**DEVELOPMENT REVIEW BOARD
RESOLUTION NO. 448**

A RESOLUTION ADOPTING FINDINGS AND CONDITIONS OF APPROVAL, APPROVING A CONDITIONAL USE PERMIT, SITE DESIGN REVIEW, AND TYPE C TREE REMOVAL PLAN FOR PGE TO UPDATE THE PEARL-SHERWOOD TRANSMISSION LINE.

Exhibit A1
Staff Report
Wilsonville Planning Division
PGE Pearl-Sherwood Transmission Line Upgrades
Development Review Board Panel 'B'
Quasi-Judicial Public Hearing

Hearing Date:	July 27, 2026
Date of Report:	July 20, 2026
Application No.:	DB25-0007 PGE Pearl-Sherwood Transmission Line Upgrades
Request/Summary:	The requests before the Development Review Board include a Conditional Use Permit, Site Design Review, and Type C Tree Plan.
Location:	The property is specifically known as Tax Lot 601, Section 2B; Tax Lots 400 and 600, Section 2CA; Tax Lots 301, 303, 304, 500, and 600, Section 2CD, Township 3 South, Range 1 West, Willamette Meridian, City of Wilsonville, Washington County; and Tax Lots 2100 and 2200, Section 11, Township 3 South, Range 1 West, Willamette Meridian, City of Wilsonville, Clackamas County, Oregon
Owners:	Garydel LLC, CCWB LLC, Eghdami Rental LLC, Stafford DC LLC, and Bonneville Power Administration (BPA)
Applicant:

Tree Removal and Power Lines

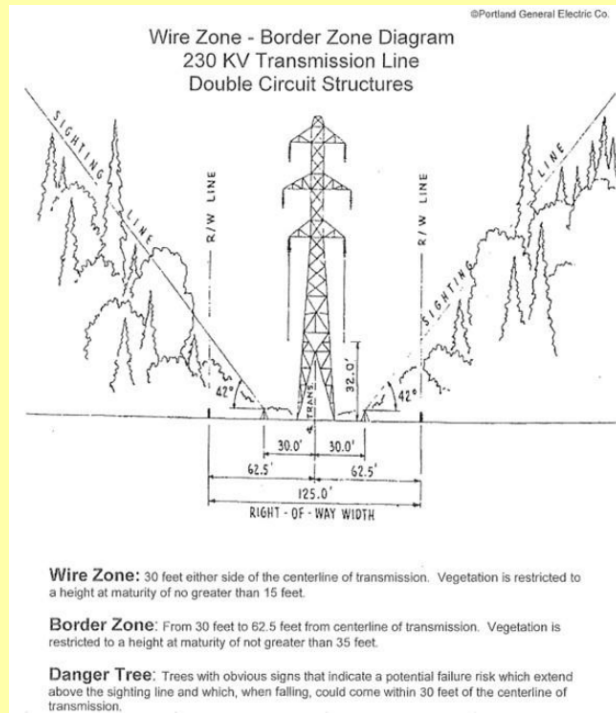
The applicant proposes to remove six (6) trees that are located on the property line of 9565 SW Ridder Road due to their proximity to the proposed high-voltage powerline. The National Electrical Safety Code (NESC) Rule 218 and PGE Transmission Vegetation Management Policy require that trees in the "wire zone" (within 30' on either side of a transmission line) be no taller than 15' at maturity and that trees in the 'border zone' (between 30' and 62.5' from the centerline of a transmission line) be no taller than 35' at maturity. The six (6) trees proposed for removal are between 33' and 37' from the transmission line wires putting them at the edge of the border zone and therefore requiring that their height be reduced to 35'.

Attention to Exterior Appearances

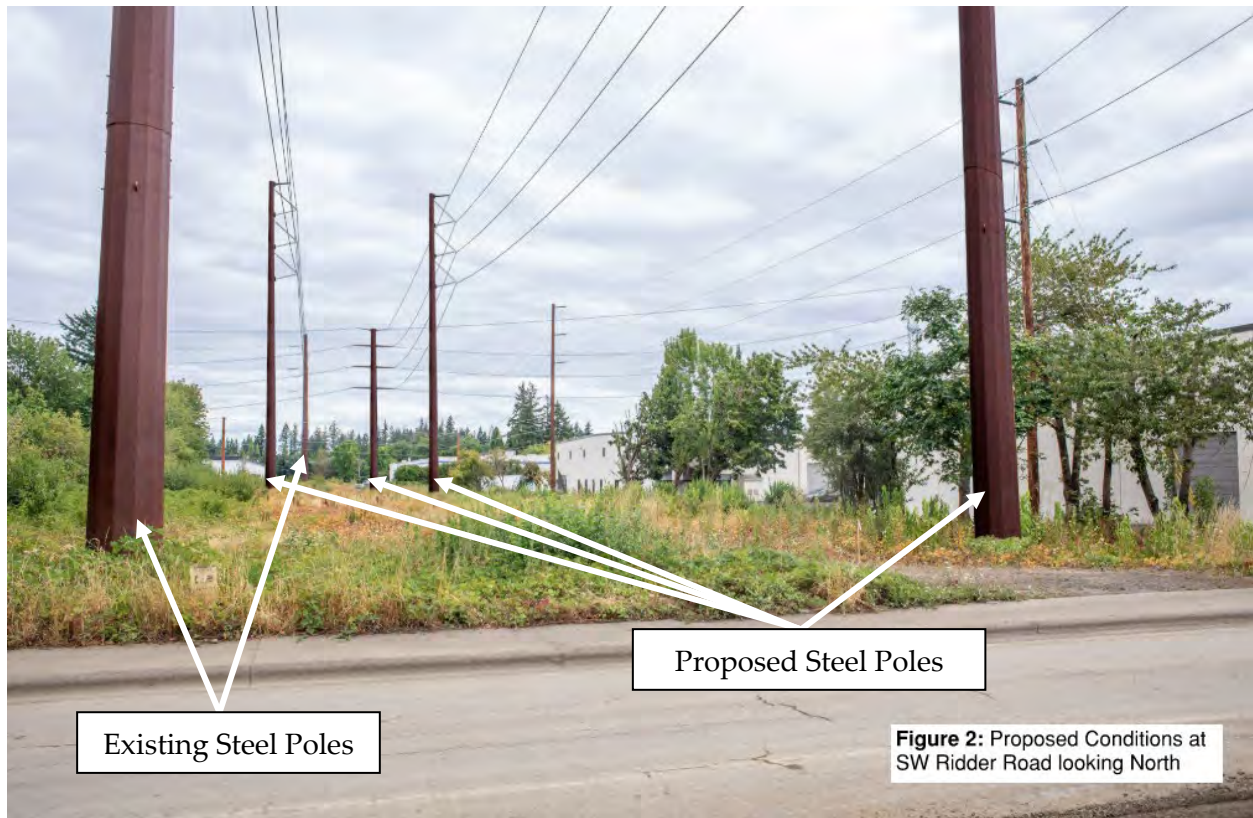
- B7.** The applicant used appropriate professional services and proposal tubular steel poles to match the existing tubular steel poles in the powerline easement. The applicant proposes the addition of new above-ground utility structures within an existing high-voltage powerline corridor limiting impacts to natural areas on surrounding properties and maintaining the established visual character of the area.

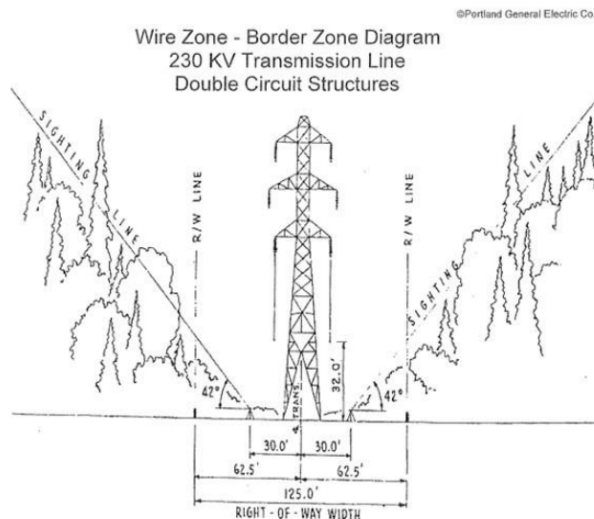
- C6.** The standards of this subsection are met as follows:
- Standard for the Significant Resource Overlay Zone: No tree removal is proposed within the SROZ with the current application.
 - Preservation and Conservation. The arborist report inventoried 12 trees on the boundary with the powerline easement and on the adjacent property at 9445 SW Ridder

Road. The inventoried trees include seven (7) Douglas fir trees and one (1) pin oak tree that were retained with prior development (Case File No. 88DR08) as well as two (2) maple landscape trees, one (1) pear landscape tree, and one (1) sweet cherry landscape tree. The applicant proposes to preserve five (5) of the Douglas fir trees and the pin oak tree on the adjacent property with minor pruning for tree health and vegetation clearance purposes. The applicant proposes to mitigate the removal of the six (6) trees with a 2:1 payment into the City Tree Fund of \$12,000, which exceeds the 1:1 mitigation requirement. Condition of Approval PDC 3 will ensure that protective fencing is placed around the drip line of preserved trees prior to site grading or other site work that could damage the trees

- **Development Alternatives:** The proposed tree removal has been minimized to the extent possible in order to accommodate the proposed modified powerline pathway. The National Electrical Safety Code (NESC) Rule 218 and PGE Transmission Vegetation Management Policy require that trees in the “wire zone” (within 30’ on either side of a transmission line) be no taller than 15’ at maturity and that trees in the ‘border zone’ (between 30’ and 62.5’ from the centerline of a transmission line) be no taller than 35’ at maturity. The six (6) trees proposed for removal are between 33’ and 37’ from the transmission line wires putting them at the edge of the border zone and therefore requiring that their height be reduced to 35’. Preservation of these trees, especially the two (2) previously retained Douglas fir which are 87’ and 92’ in height, would require significant crown reduction to 35’ that would result in tree mortality.

Wire Zone: 30 feet either side of the centerline of transmission. Vegetation is restricted to a height at maturity of no greater than 15 feet.
